# ULTRA LEVEL TECH. CO., LTD.

<b>Subject:</b>	<b>Product Change Notice (PCN)</b>	<b>Date:</b>	2018/10/22
-----------------	------------------------------------	--------------	------------

RL0603 and RL0603D series

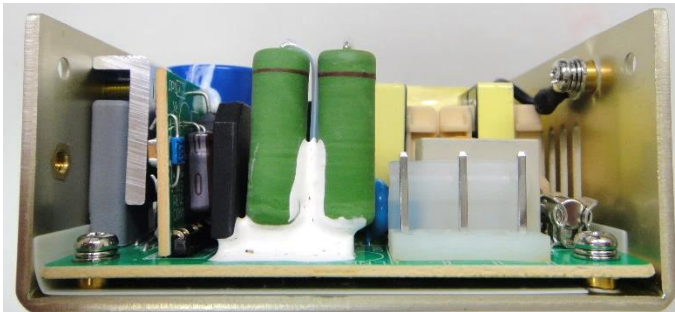
IEC/EN/UL 62368-1 clause 5.6.4.1 protective bonding conductors and size- Adding jump wire (diameter min. 0.8mm, complies 0.5 mm<sup>2</sup>) complies with Table 31 and resistance of the protective bonding system (5.6.6.2) test.

IEC/EN/UL 60950-1 version

IEC/EN/UL 62368-1 Version

New orders for delivery date after Jan. 1, 2019 will be produced in IEC/EN/UL 62368-1 version.
